(Special Advisory No.18-2A supersedes and voids Special Advisory No.18-2 dated September 19, 1989)

**Aileron and Flap Hinge  
Bracket Attaching Hardware**

PA-18-150 Super Cub

FIG. 1 VIEW OF TRAILING EDGE OF WING  
LOOKING UP

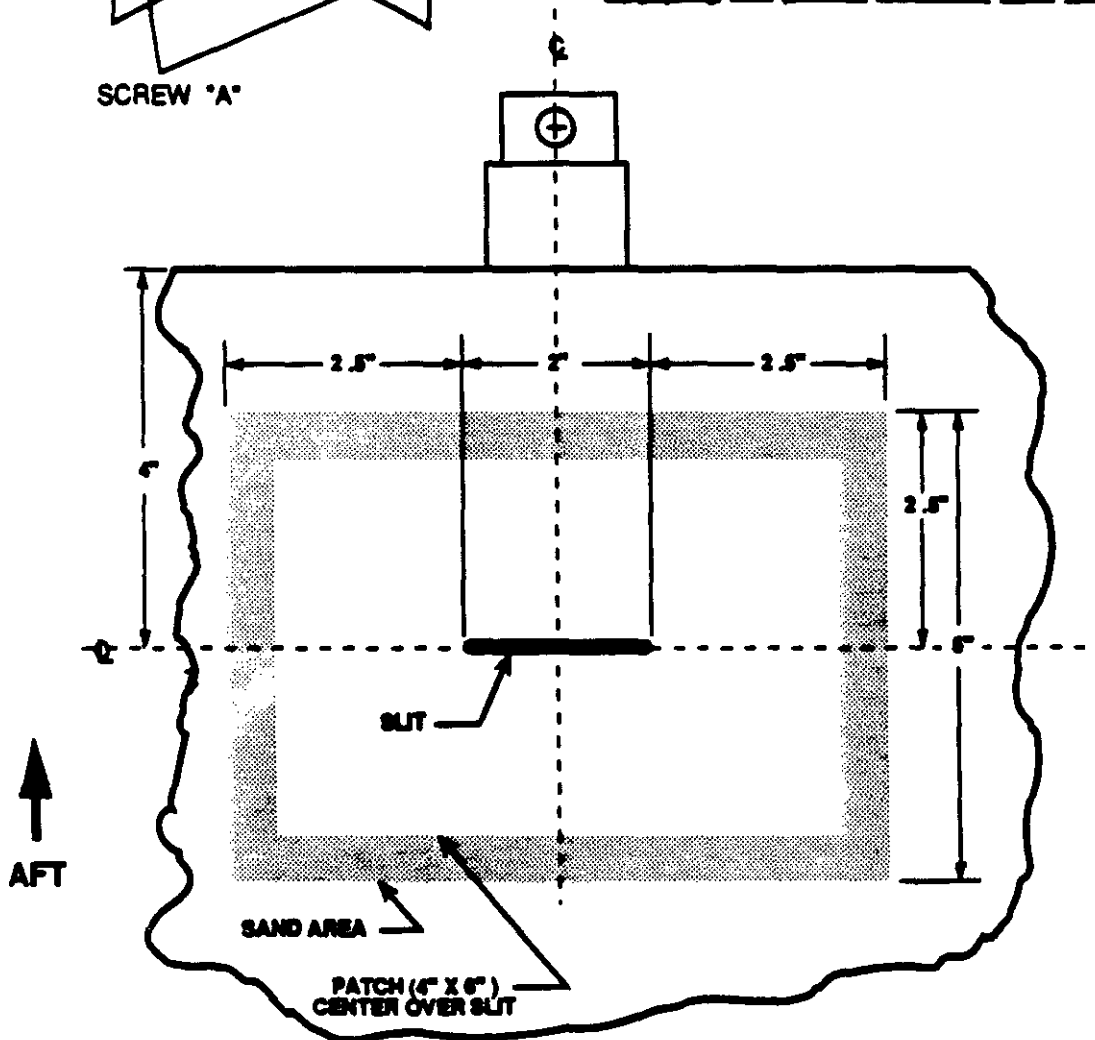
1. Locate each aileron and flap hinge bracket on left and right wings.
2. Measure approximately four (4) inches forward of the false spar at each hinge bracket on the underside of the wing to locate inspection slits.
3. Cut the inspection slit, spanwise two (2) inches, one inch each side of hinge center line.

Prior to cutting an inspection slit, check the airframe logbook for type of finish, then clean and sand the area per the instructions on Sketch "A", Fig. 1.

13. Apply fabric patches (use Blue River 7600 Material) to underside of wing and dollar patches (use Piper Part Number 89209-002 Patches) as necessary to the false spar where screws were removed per the instructions on Sketch "A".

If the finish coat is Flexi-Gloss, the area must be thoroughly cleaned to remove any waxes, silicones, or contaminants which might be present. Scuff sand. Apply two coats of 7602 Cement in the area sanded around the slit. Allow this to dry completely before activating and applying the patch. Brush a second coat of activator on the patch and wipe off with a paper towel or soft cloth. Allow to dry overnight and then heat tauten the center area over the hole only. Apply filler coat, sand and spray with Flexi-Gloss. If the top coat is not Flexi-Gloss, you must sand down to the filler coat before applying the patch. Refinish with matching final finish.

FIG. 2

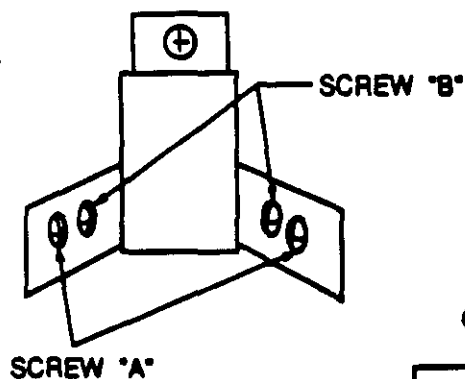
11. Install one (1) each rivet, Piper Part Number 523-121 (NAS1768D-4-2) in each hole where a screw was removed.
12. If it is necessary to remove all four (4) screws in any one bracket, refer to Sketch "A", Fig. 2. Remove screws "A" first and install rivets. Then remove screws "B" and install rivets.
